Well Name: NUGGET 6_31 FEDERAL COM	Well Location: T24S / R31E / SEC 7 / NENW / 32.2383088 / -103.8200539	County or Parish/State: EDDY / NM
Well Number: 12H	Type of Well: OIL WELL	Allottee or Tribe Name:
Lease Number: NMNM82904	Unit or CA Name:	Unit or CA Number:
US Well Number: 3001556047	Operator: OXY USA INCORPORATED

Sundry ID: 2834552

Type of Submission: Notice of Intent	Type of Action: APD Change
Date Sundry Submitted: 01/30/2025	Time Sundry Submitted: 08:35
Date proposed operation will begin: 03/15/2025

Procedure Description: Oxy respectfully requests approval to change the surface hole location from NENW 294' FNL & 1732' FWL Section 7, T24S, R31E to NENW 418' FNL & 1612' FWL Section 7, T24S, R31E; as well as the bottom hole location. Also included is the blanket A casing design. There will be no additional surface disturbance related to this sundry.

6. Wellbore Diagram(s)

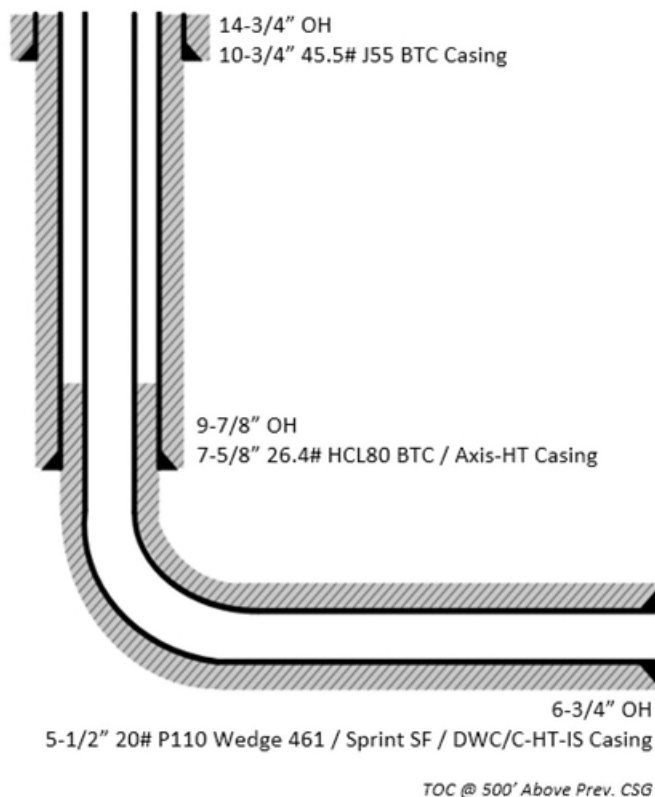
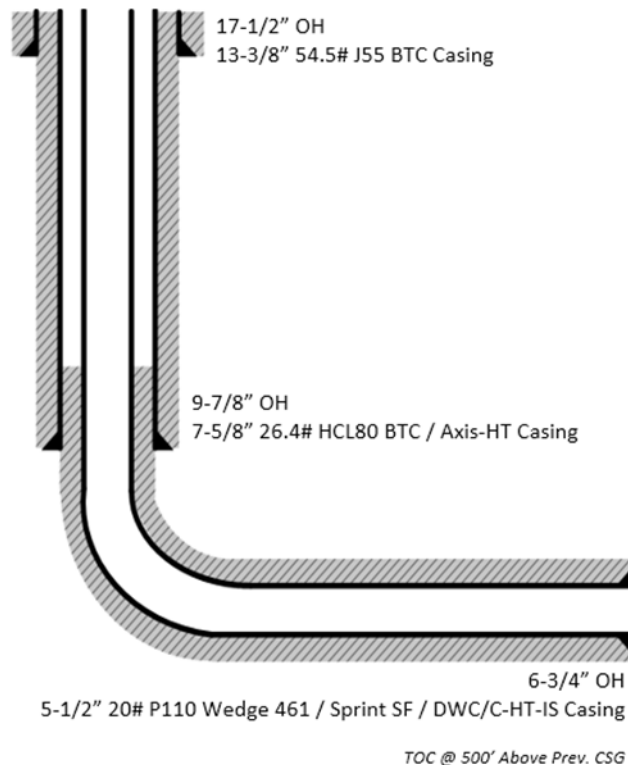
NOTE: WELL APPROVED FOR DESIGNS A1 AND A2. REVIEW CEMENT VOLUMES TO ACHIEVE TIE BACKS LISTED BELOW.

1. The **10-3/4** inch surface casing shall be set at approximately **870** feet (a minimum of 25 feet (Lea County) into the Rustler Anhydrite, above the salt, and below usable fresh water) and cemented to the surface.

- d. If cement falls back, remedial cementing will be done prior to drilling out that string.
2. The **7-5/8** inch intermediate casing shall be set at approximately **8417** feet. **KEEP CASING 1/2 FULL FOR COLLAPSE SF. PRESSURE TEST NEEDS EXTERNAL PRESSURE REVIEW AS WELL.** The minimum required fill of cement behind the **7-5/8** inch intermediate casing is:

3. The 5-1/2 inch production casing shall be set at approximately **19,824** feet. The minimum required fill of cement behind the 5-1/2 inch production casing is:

1. The 13-3/8 inch surface casing shall be set at approximately **870** feet (a minimum of 25 feet (Lea County) into the Rustler Anhydrite, above the salt, and below usable fresh water) and cemented to the surface.

- h. If cement falls back, remedial cementing will be done prior to drilling out that string.
2. The 7-5/8 inch intermediate casing shall be set at approximately **8417** feet. **KEEP CASING 1/2 FULL FOR COLLAPSE SF. PRESSURE TEST NEEDS**

EXTERNAL PRESSURE REVIEW AS WELL. The minimum required fill of cement behind the 7-5/8 inch intermediate casing is:
